Name of Dam: Whites Dam

Inventory Number: VA 00327

PHASE I INSPECTION REPORT NATIONAL DAM SAFETY PROGRAM

PREPARED BY
MICHAEL BAKER, JR., INC.
BEAVER, PENNSYLVANIA 15009

PLATE 1

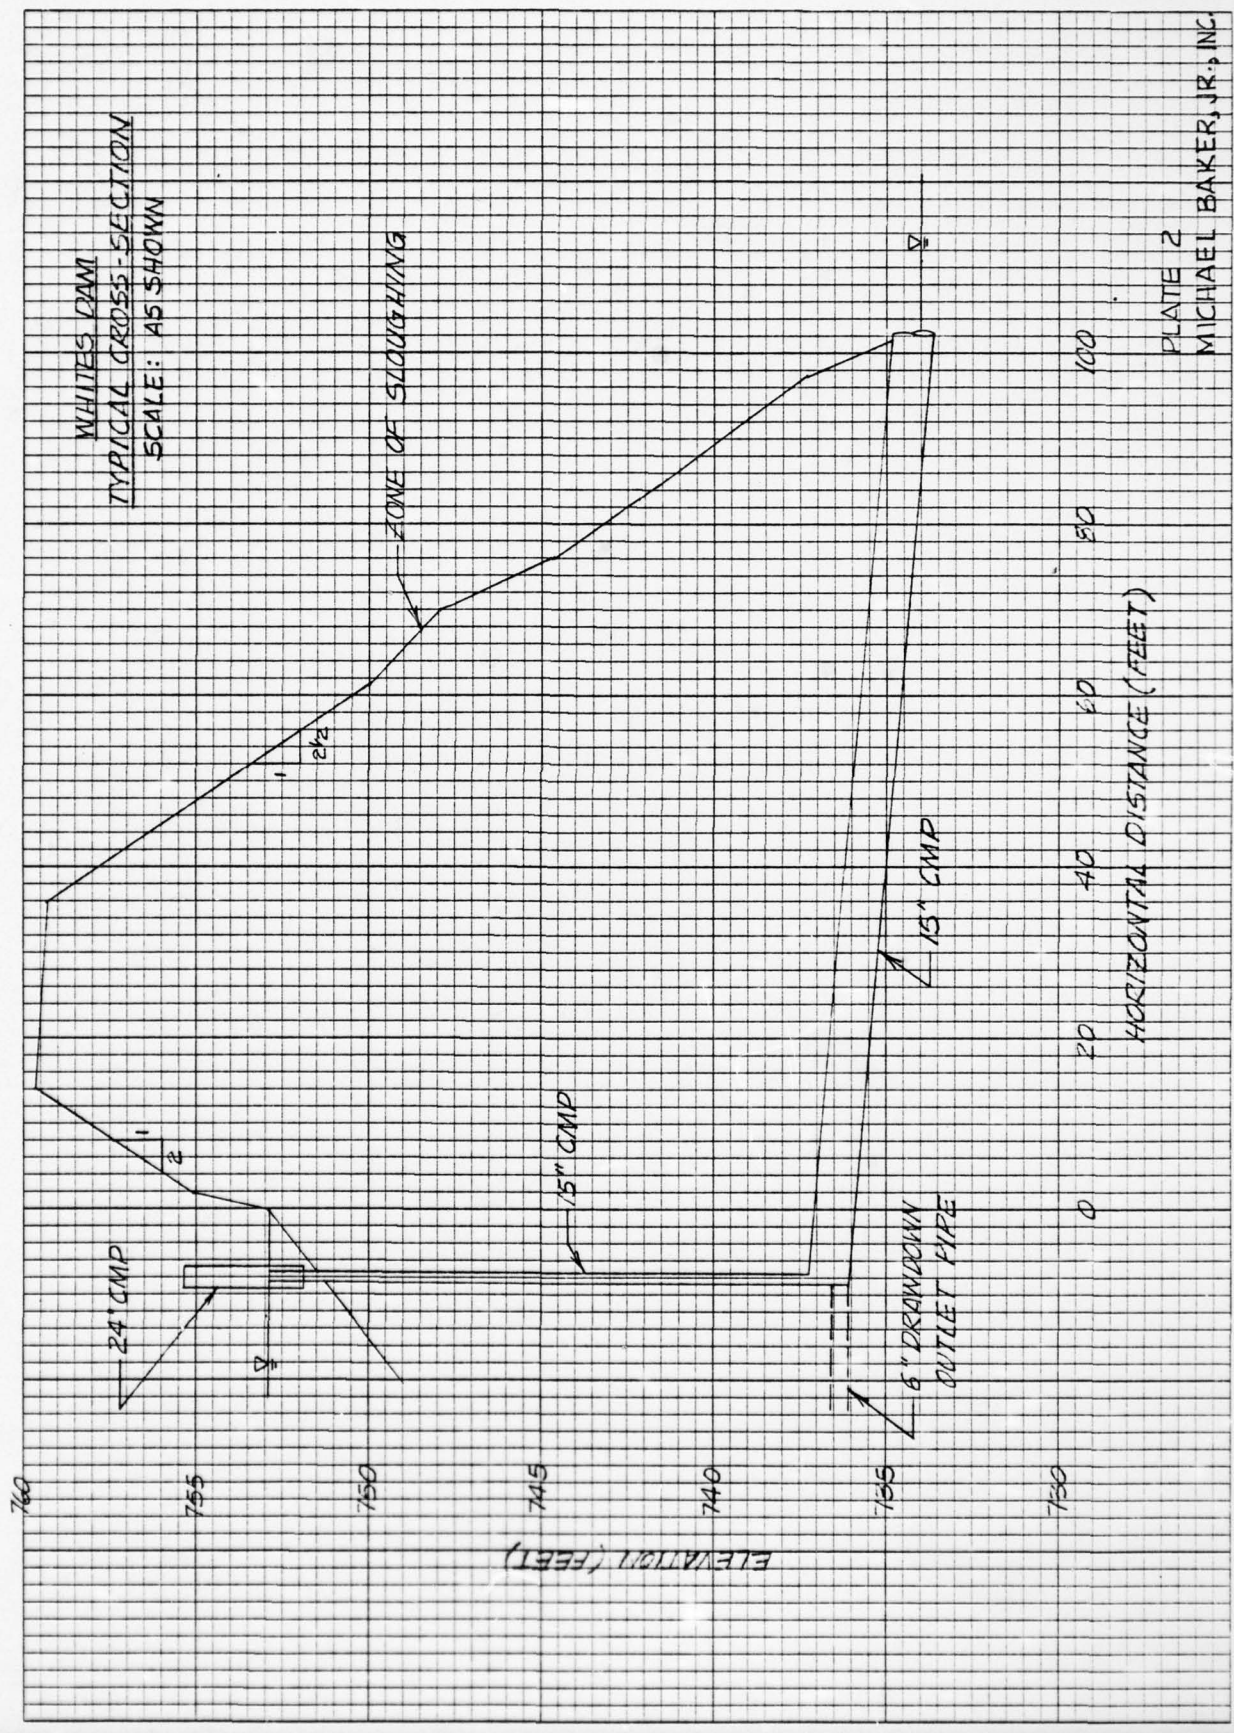
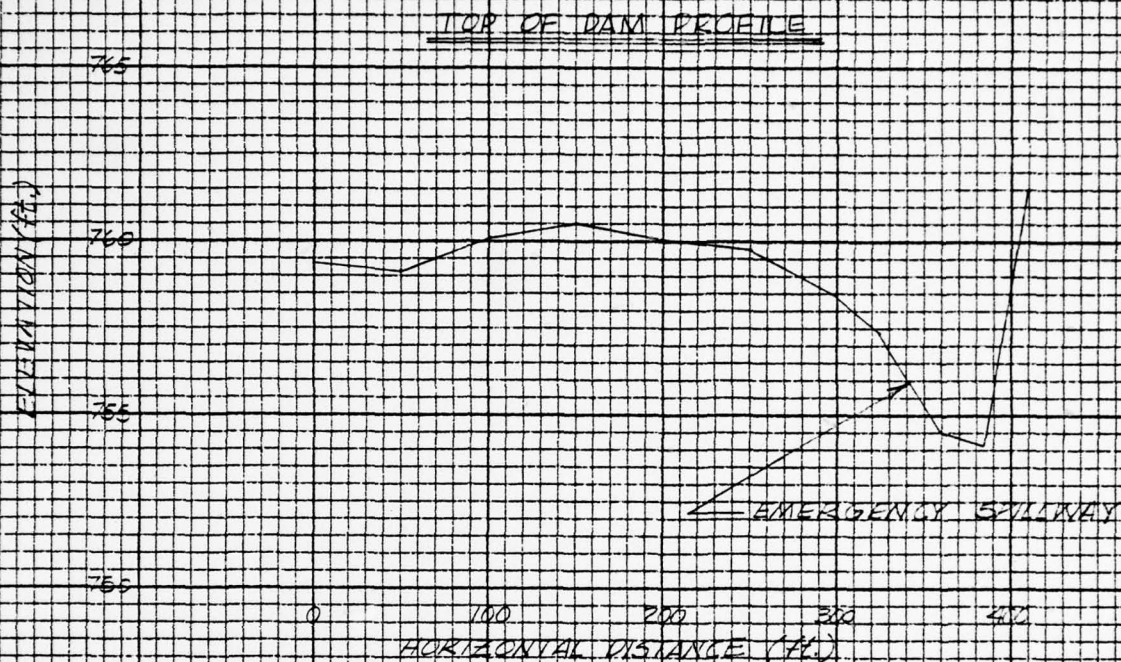
Plate 1 is a Field Sketch of the dam which illustrates the conditions observed during the visual inspection. The complete visual inspection check list is included in Appendix III. Following are summaries of the deficiencies noted during the inspection.

- 3.1.2 Dam: Step-like slumping of the lower half of the downstream slope of the embankment (slope 2.5:1) has occurred at this facility (see Plate 1). Displacements of up to 2 feet along the more distinct slump scarps were noted. Each slump is less than 3 feet in width. The lower half of the slope is sparsely vegetated and the slumped areas are eroded (see Photo 5). The disturbed embankment material is firm and no seeps were detected in the slumped areas. The downstream toe area of the dam on either side of the outlet channel is very swampy, but no seepage was detected. Surface drainage is poor, probably due to the poor condition of the downstream channel, and the vegetation is thick (see Photo 3) in this area.

- 7.2 Recommended Remedial Measures: Because this is a high hazard dam with relatively steep embankment slopes, it is recommended that an investigation and stability analyses be performed by a qualified professional engineering firm. It is recommended that the step-like slumps on the lower half of the downstream embankment slope be repaired as soon as possible to prevent further deterioration. The slump area should be graded, filled where necessary, compacted, and seeded. The discharge channel from the outlet pipe should be improved to allow drainage away from the outlet pipe and the swampy areas along the toe of the dam. Riprap protection should be placed around the outlet pipe. The erosion along the waterline of the upstream embankment slope should be repaired and riprap should be placed on the slope to protect it from further erosion.
